**Re: November 1 Committee of the Whole Public Meeting Agenda Item 4 – Weston 7 Secondary Plan File No. 26.2**

Urban Strategies Inc., are the land use planners for RioCan REIT (“**RioCan**”) with respect to their lands at 7501-7621 Weston Road, also known as the Colossus Centre, a 25-hectare site south and east of Highway 7 and Weston Road (the “**Colossus Centre Site**”). The Colossus Centre Site is currently the subject of active official plan amendment applications (OP.22.002 and OP.22.005) which were submitted March 1, 2022 and deemed complete on July 23, 2022 (the “**Colossus OPA Applications**”).

## **Commentary on Draft 2 Weston 7 Secondary Plan**

## Appendix C - 1

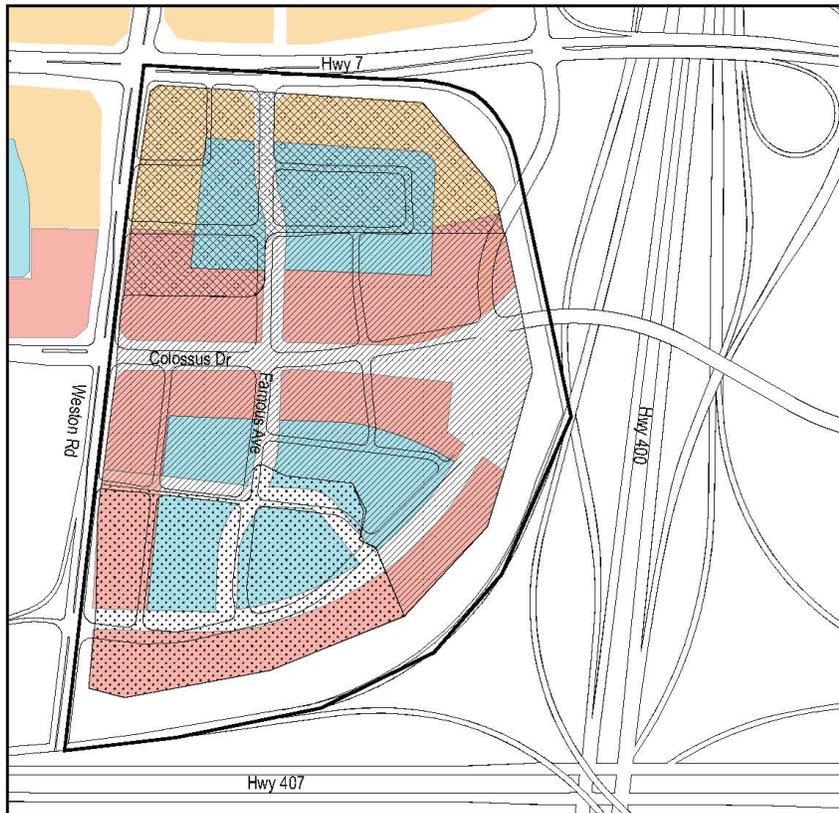
The Plan's approach to Mid-Rise and High-Rise buildings is articulated in Section 4.2.3 and 4.2.4 and illustrated on Schedule 2. In our opinion, the rationale for the proposed building height ranges on the RioCan lands remains unclear.

As illustrated in the graphic overlay included as Appendix C-1 to this letter, RioCan's proposed OPA and quadrant wide-master plan proposes a different approach to heights with higher heights and predominantly tower podium form buildings in the northerly precinct with the height range transitioning down in the southerly precinct where there is greater mix of mid and high rise typologies envisioned. We remain of the opinion that the Plan's proposed height regime is not appropriately reflective of the scale of development that should be contemplated in Weston 7.

Further, it is our opinion that greater heights are achievable while still maintaining an appropriate complementary relationship to the scale of development in the VMC. Schedule 3 in the W7SP should be updated to more closely align with the heights proposed in the RioCan OPA and Colossus Masterplan, which, based on our initial high-level calculations, do not result in a greater density output than what is proposed by the W7SP on a gross site basis. RioCan's OPA proposed a gross density of 4.0 FSI.
